UNITED STATES
DEPARTMENT OF THE INTERIOR
BUREAU OF LAND MANAGEMENT
ARTESIA DISTRICTFORM APPROVED
OMB NO. 1004-0137
Expires: January 31, 2018**SUNDRY NOTICES AND REPORTS ON WELLS**
Do not use this form for proposals to drill or to re-enter an abandoned well. Use form 3160-3 (APD) for such proposals.5. Lease Serial No.
NMLC029342A

8. Well Name and No.
WOOLLEY FEDERAL 79. API Well No.
30-015-31258-00-S110. Field and Pool or Exploratory Area
LOCO HILLS-QU-GB-SA11. County or Parish, State
EDDY COUNTY, NM

Woolley Federal #7 Wellbore diagram

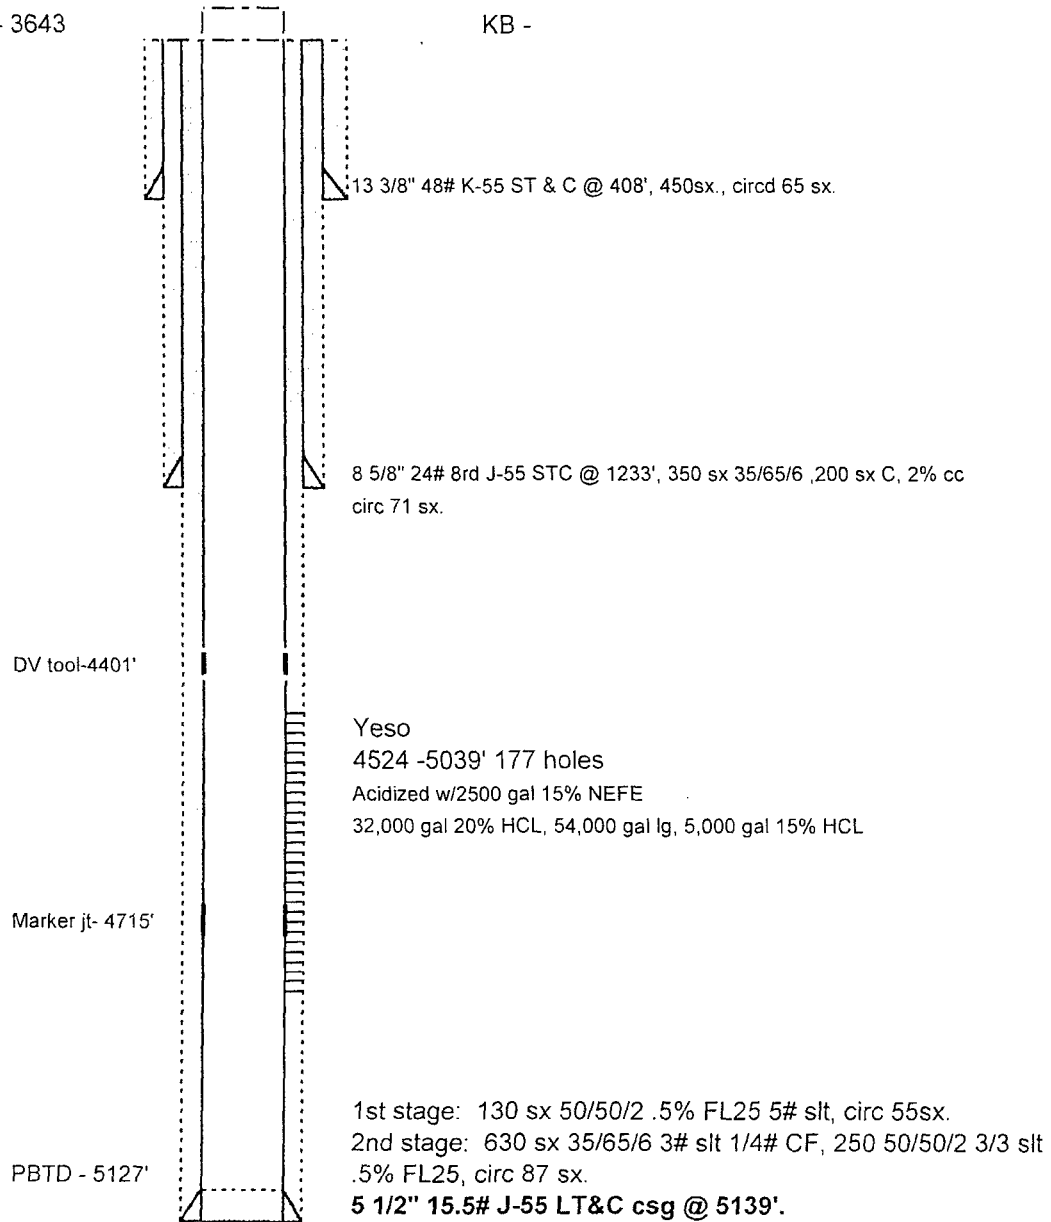
** BLM REVISED ** BLM REVISED ** BLM REVISED ** BLM REVISED ** BLM REVISED **

4. Spot 55 sx cmt @ 460- Surface. (Shoe)

RECLAMATION PROCEDURE
ATTACHEDSEE ATTACHED FOR
CONDITIONS OF APPROVAL*Below ground level dry hole marker required*
